**MONTGOMERY COUNTY HISTORIC PRESERVATION COMMISSION**  
**STAFF REPORT**

<b>Address:</b>	5912 Cedar Parkway., Chevy Chase	<b>Meeting Date:</b>	1/25/2017
<b>Resource:</b>	<b>Contributing Resource</b> Chevy Chase Village Historic District	<b>Report Date:</b>	1/18/2017
<b>Applicant:</b>	Blake and Sydney Bath (Luke Olson, Architect)	<b>Public Notice:</b>	1/11/2017
<b>Review:</b>	HAWP	<b>Tax Credit:</b>	N/A
<b>Case Number:</b>	35/13-17B	<b>Staff:</b>	Michael Kyne
<b>PROPOSAL:</b>	Rear addition and other alterations

REAR VIEW - PROPOSED

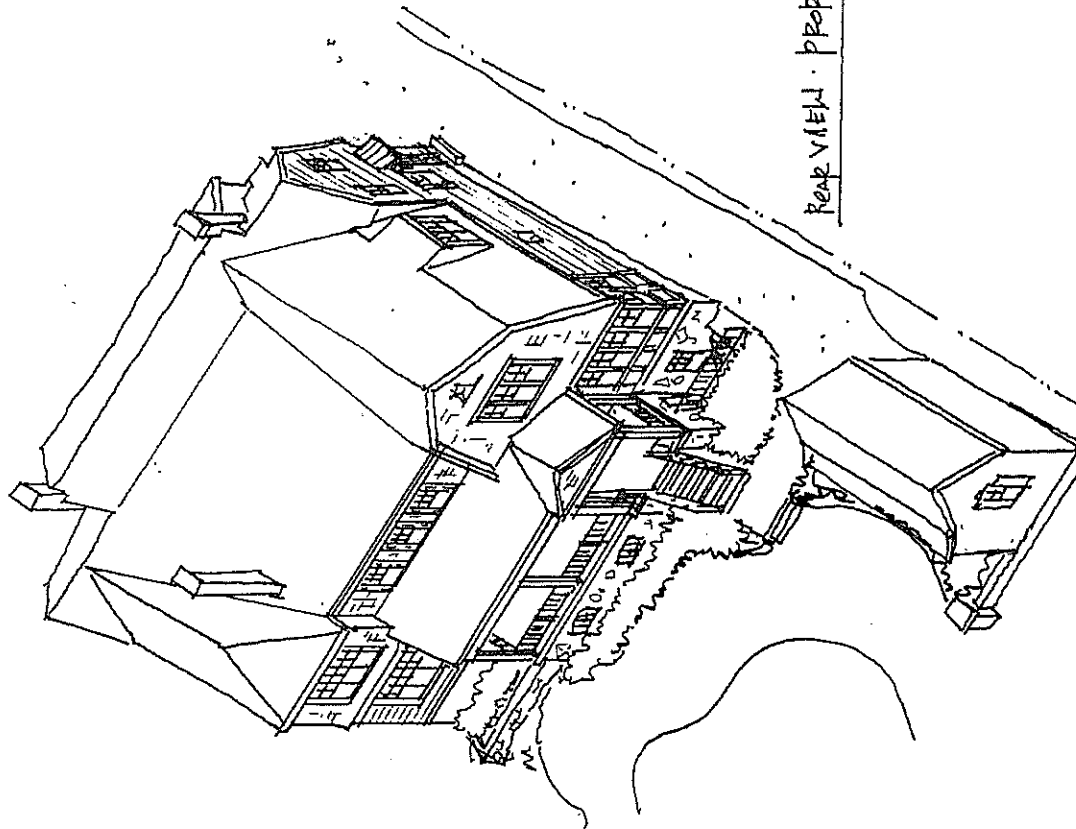
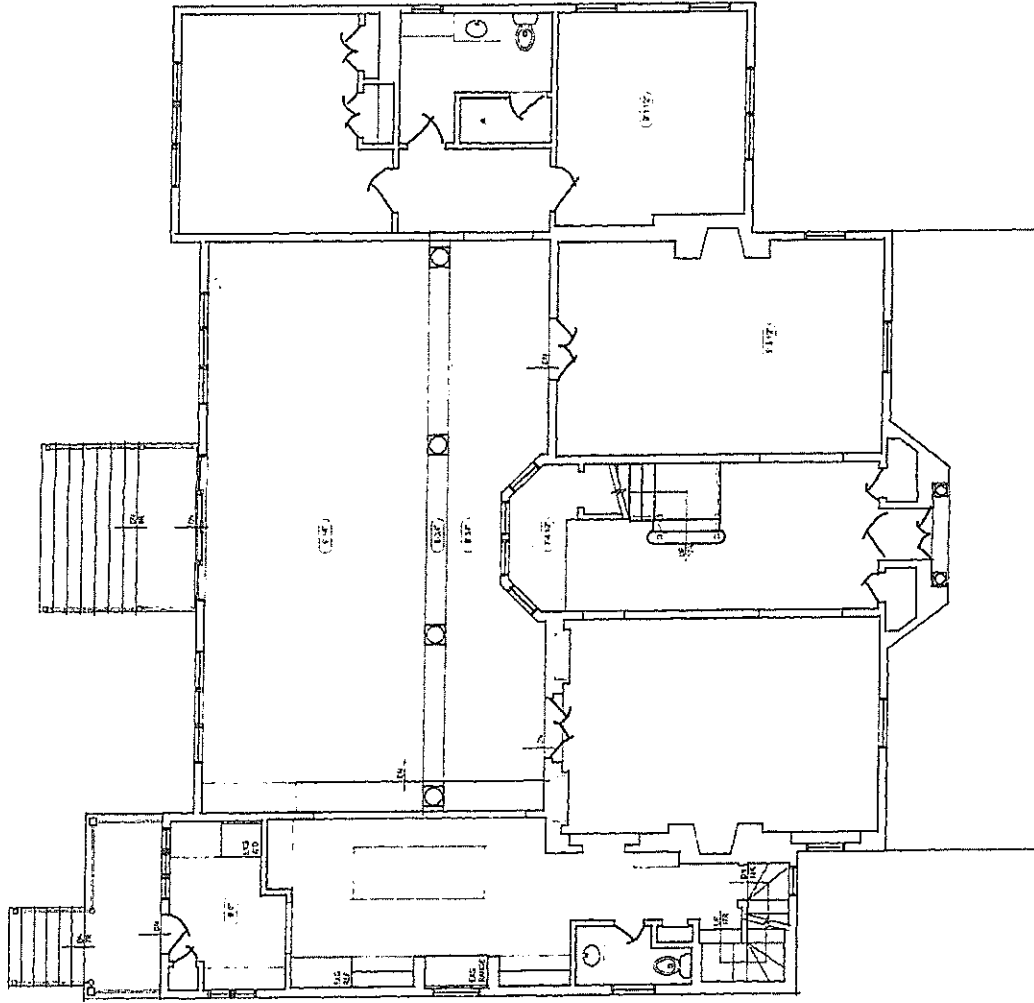
- The rear roof/rear-facing gable of the c. 2000 right side addition will be converted to a hipped roof. At the preliminary consultation, the applicants presented two options – Option A, which included the proposed hipped roof alteration, and Option B, which retained the rear-facing gable. The Commission voiced support for both options, as the proposed alteration was at the rear, where it is not at all visible from the public right-of-way.

- The proposed fenestration for the rear addition has been revised, with four ganged double-hung windows with spread mulls replacing the previously proposed three double-hung windows on the second-floor, and with transom windows being proposed across the entire first-floor porch. Two new round windows are also proposed on the rear elevation – one that replaces the previously proposed square window in the gable of the proposed new rear-facing gambrel roof, and one on the second-floor above the proposed new rear porch.

The proposed fenestration revisions are on the rear elevation, where they are not at visible from the public right-of-way, and the Commission did not review the previously proposed alterations on the rear elevation with a great deal of scrutiny. Accordingly, staff supports the proposed fenestration revisions, finding that they will not detract from the subject property or surrounding historic district.

PHOTO OF EXG. LEFT SIDE ELEV.

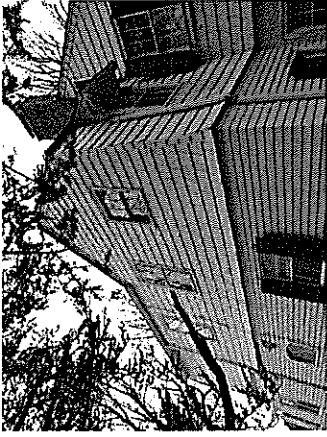
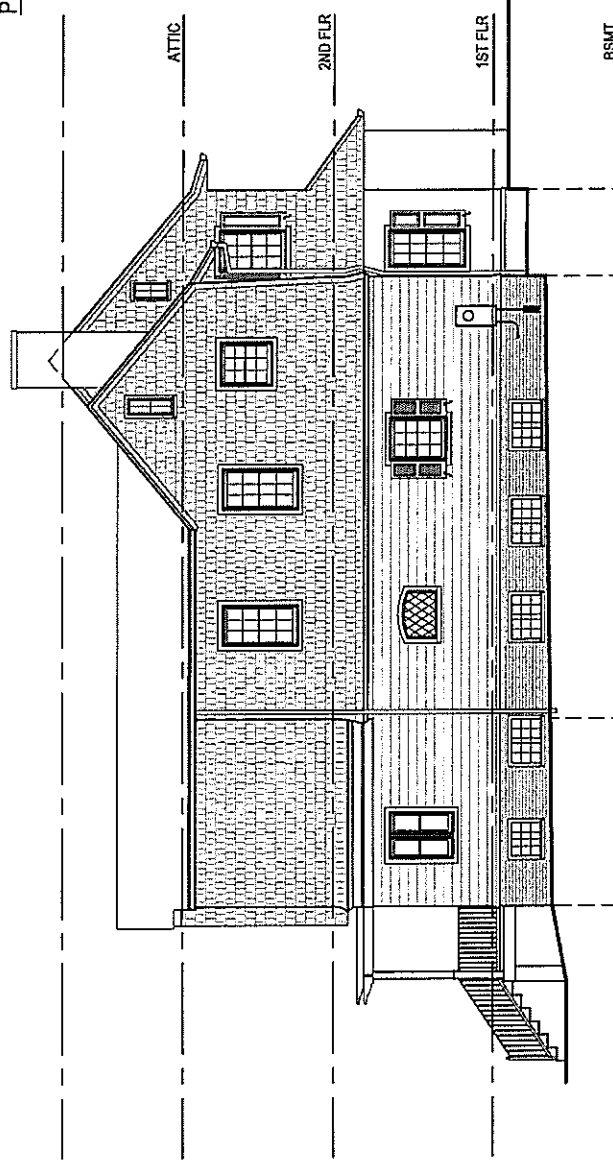
- The applicants also propose several new window alterations on the left elevation of the existing left side bump out: two basement-level windows will be infilled; the second-floor window, which was previously proposed to be infilled, will be permanently shuttered; the non-historic leaded glass window (c. 2000 renovations) will be infilled, with new ribbon windows installed above; and the previously proposed double-hung window at the rear corner will instead be paired double-hung windows with a spread mull and Azek surrounds and panelling.

- The Commission has generally reviewed proposals to infill basement-level windows on side elevations with lenient scrutiny.
- Shuttering the second-floor window is a more appropriate approach, which will allow the location of the original window to be discerned. This revision was made at staff's suggestion.
- The applicants have provided the following information, indicating that the leaded glass window is non-historic: the window is not a true leaded glass window, but has an applied grid on the interior; the trim on the exterior of the window matches that on the c. 2000 right-side addition; the window is an integral part of the range, which

- The Commission was supportive of the previously proposed single double-hung window at the rear corner, which included similar surrounds and panelling, although the materials were not known at that time. Staff suggests that making this a paired window is a relatively minor alteration.

LEFT SIDE (DRIVEWAY) ELEVATION - PROPOSED

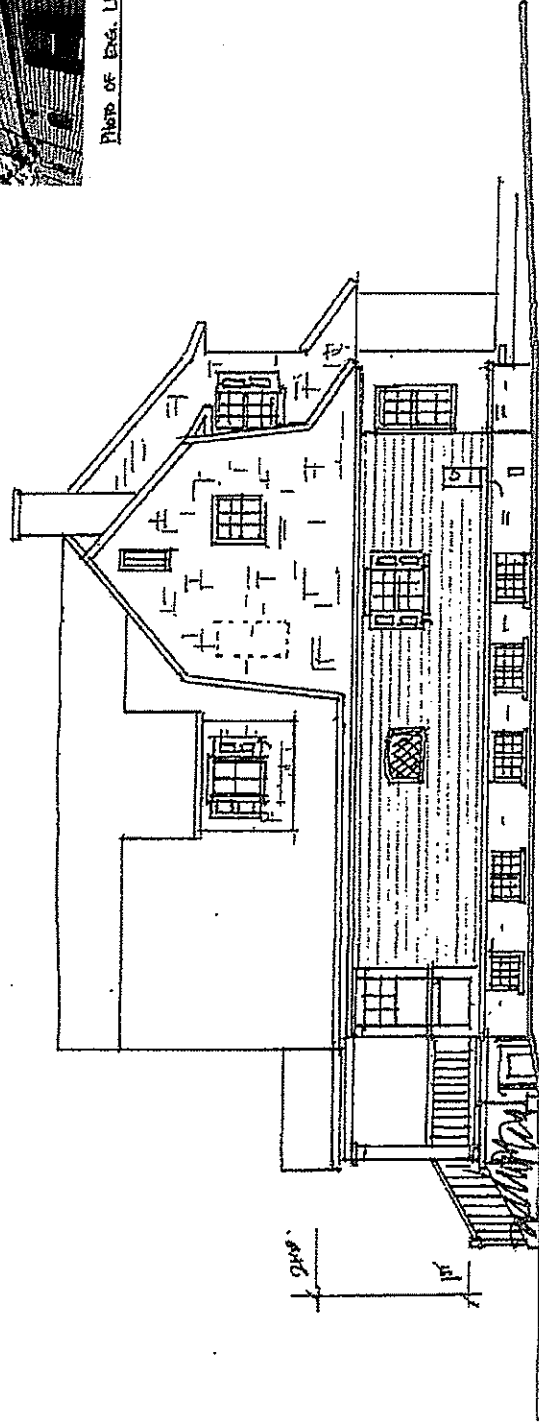
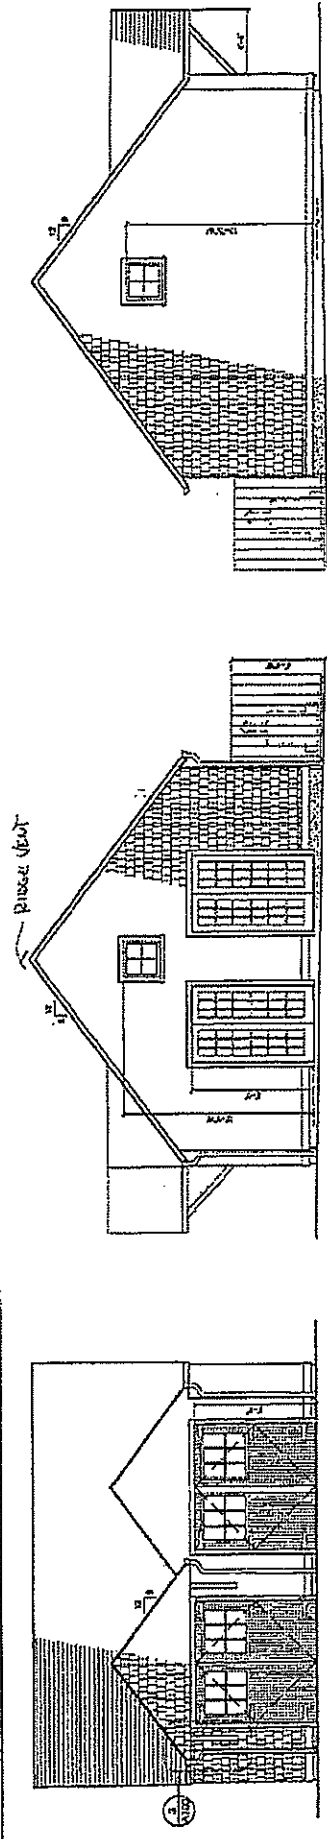
19 MS. BARNES: My question relates to the proposed  
20 mud room entry, and the alteration of the front facade by  
21 putting in a door and a canopy over the door. And I'm  
22 curious as to whether, because you just referred to the  
23 issue of sort of breaking up the very long wall, which is  
24 not visible from the street. Was any thought given to an  
25 entry into the mudroom, not in the front of the house, but

13 MS. BARNES: It may be a logical place, but if one  
14 is looking at the question of an alteration to a historic  
15 resource, and one that's visible from the street, the  
16 changing from a small window to a door with steps and a  
17 canopy, represents a substantial change. So, that is for me  
18 an issue, and that's why I was curious to hear if there had  
19 been thought given to some other approach. I appreciate  
20 what you're saying about convenience.

17 MS. BARNES: You heard me in the very beginning  
18 raise the question of the door to the mudroom. That is, for  
19 me, a serious problem. I notice that you were using a  
20 window aperture to turn it into a door. There is a current  
21 window aperture on the side, now I think went to a powder  
22 room. That perhaps offers you the opportunity to do a door  
23 on the side for your mudroom. And, I take the point that it  
24 would be better to have it closer to the front rather than  
25 far in the back.

2 MR. OLSEN: The issue that we've kind of  
3 encountered with that, number one, this house is set back  
4 pretty far from the street, so any mudroom entry that far  
5 back would be even further back. It's a pretty long  
6 distance to have to go to enter your house. It's also very  
7 tight on that side. So, if you're trying to park a car and  
8 get up steps into a mudroom entry, it's going to project  
9 even further into that space and just be very uncomfortable.  
10 And so this seems like the most logical place to have a  
11 mudroom entry, given kind of the siting and the plan of the  
12 house.
